South Texas Project Electric Generating Station P.O. Box 289 Wadsworth, Texas 77483

August 2, 2001  
NOC-AE-01001137  
File No.: G20.02.01  
G21.02.01  
10CFR50.90

South Texas Project  
Units 1 and 2  
Docket Nos. STN 50-498, STN 50-499  
Proposed Amendment to Technical Specification 3/4.6.1.6,  
"Containment Structural Integrity"

**PROPOSED AMENDMENT TO TECHNICAL SPECIFICATION 3/4.6.1.6,  
“CONTAINMENT STRUCTURAL INTEGRITY”**

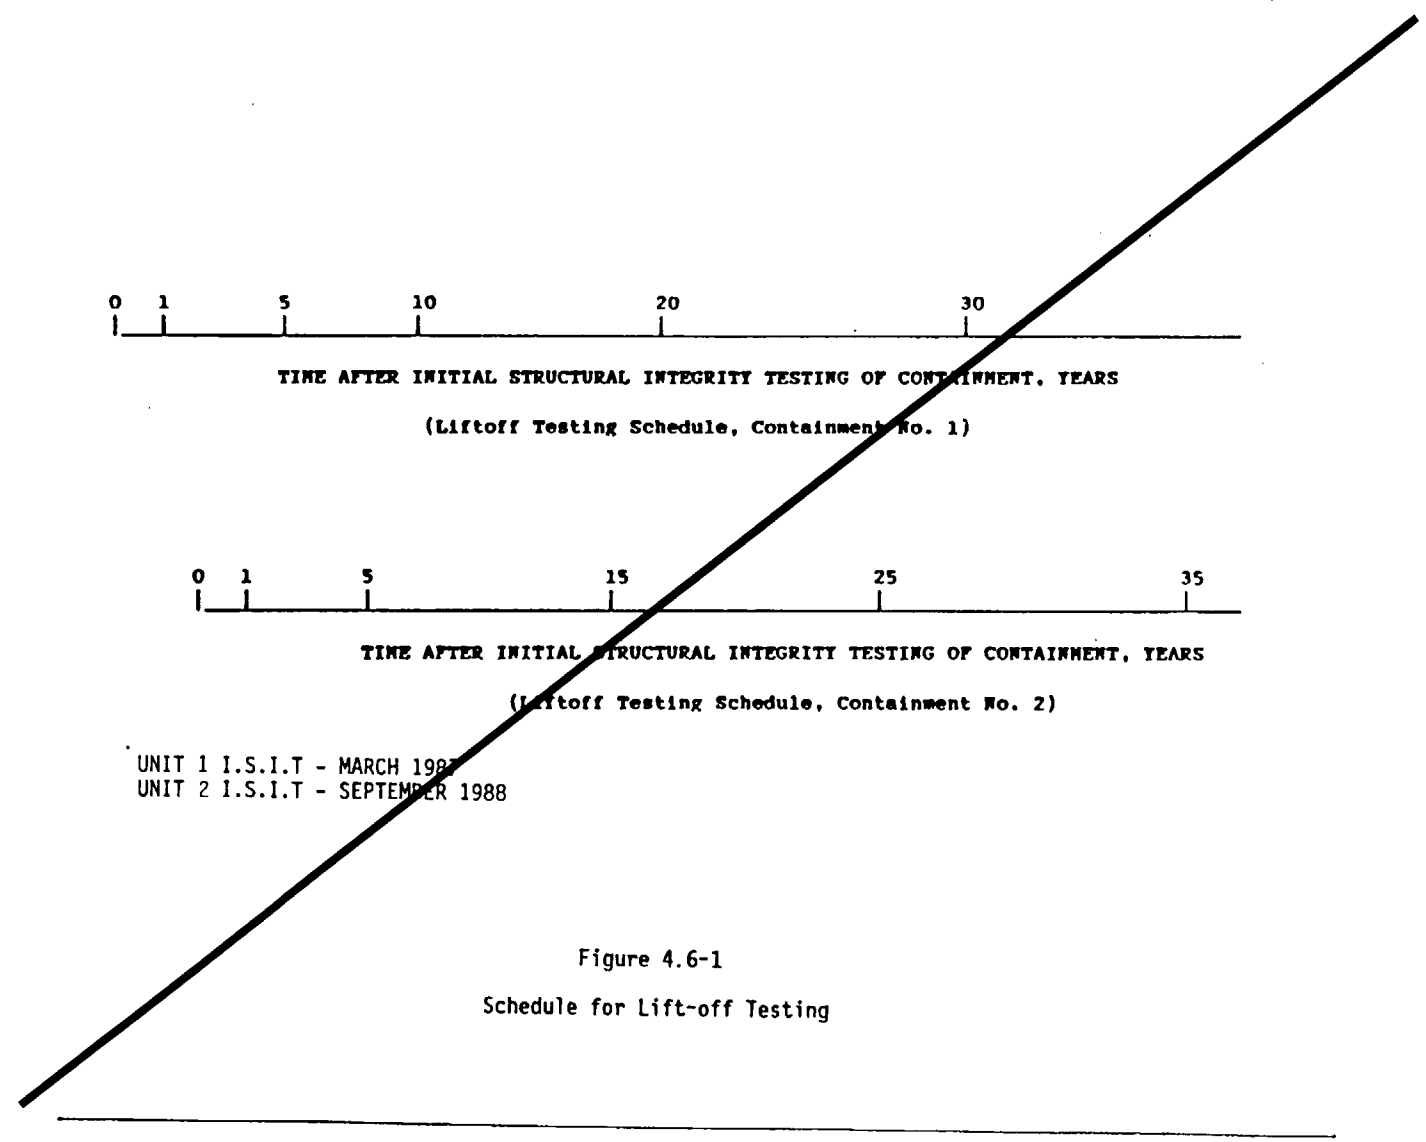
The structural integrity of the prestressing tendons of the containment shall be demonstrated at the end of 1, 3, and 5 years following the initial containment structural integrity test and at 5 year intervals thereafter. The inspection schedule for lift-off testing shall be as shown in Figure 4.6-1.

- b. Performing tendon detensioning, inspections, and material tests on a previously stressed tendon. Two tendons, one from each group shall be detensioned each time lift-offs are performed per Figure 4.6-1. A randomly selected tendon shall be completely detensioned in order to identify broken or damaged wires and determining that over the entire length of the removed wire sample (which should include the broken wire if so identified) that:

~~4.6.1.6.2 —End Anchorages and Adjacent Concrete Surfaces. As an assurance of the structural integrity of the containment(s), tendon anchorage assembly hardware (such as bearing plates, stressing washers, wedges, and buttonheads) of all tendons selected for inspection shall be visually examined. During combined inspection (See Figure 4.6-1), for the containment not having full inspection, only visual inspection need to be performed. The sample size for visual only inspection is the same as for full inspection (see 4.6.1.6.1.a). Tendon anchorages selected for inspection shall be visually examined to the extent practical without dismantling the load bearing components of the anchorages. Bottom grease caps of all vertical tendons shall be visually inspected to detect grease leakage or grease cap deformations. The surrounding concrete should also be checked visually for indication of any abnormal condition.~~

~~Significant grease leakage, grease cap deformation or abnormal concrete condition shall be considered as an indication of abnormal degradation of containment structure.~~

~~4.6.1.6.3 —Containment Surfaces. The exterior surface of the containment(s) should be visually examined to detect areas of large spall, severe scaling, D-cracking in an area of 25 sq. ft. or more, other surface deterioration or disintegration, or significant grease leakage, each of which can be considered as evidence of abnormal degradation of structural integrity of the containment(s).~~

DELETED

PAGES 3/4 6-10, 6-11, 6-11A, AND 6-11B HAVE BEEN DELETED.
